Product Change Notification

PCN #: 20190905-3

Manufacturing process changes in production of coil-terminal subcomponents.

AZSR180, AZSR235 and AZSR250 series, without exception.

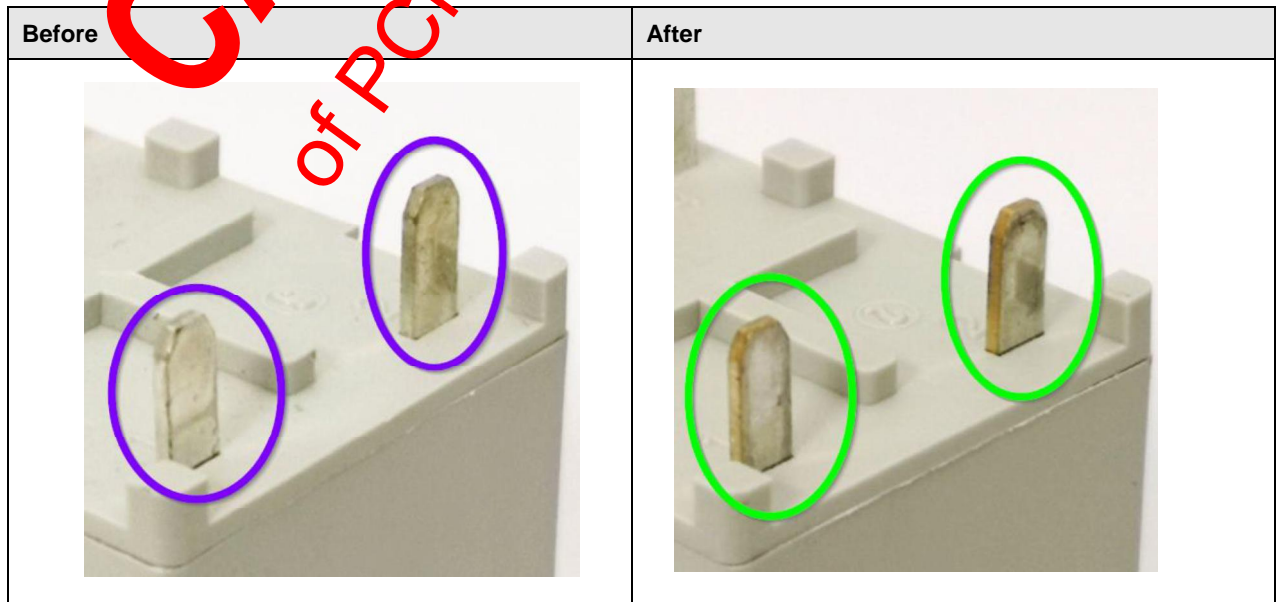
Improvement of part quality and stability of pin insertion process at automating winding machine.

Increase of yield in subcomponent manufacturing by prevention of physical damage of subcomponents during galvanic processes.

Change of raw material and type of the coating for coil pin of solar relays type AZSR235, AZSR250, AZSR280.

Current process: Stamping of coil-terminal subcomponent from brass tape (CuZn33), then galvanic coating with Sn.

New process: Hot dip plating of brass tape (CuZn33), then stamping of coil-terminal subcomponent.
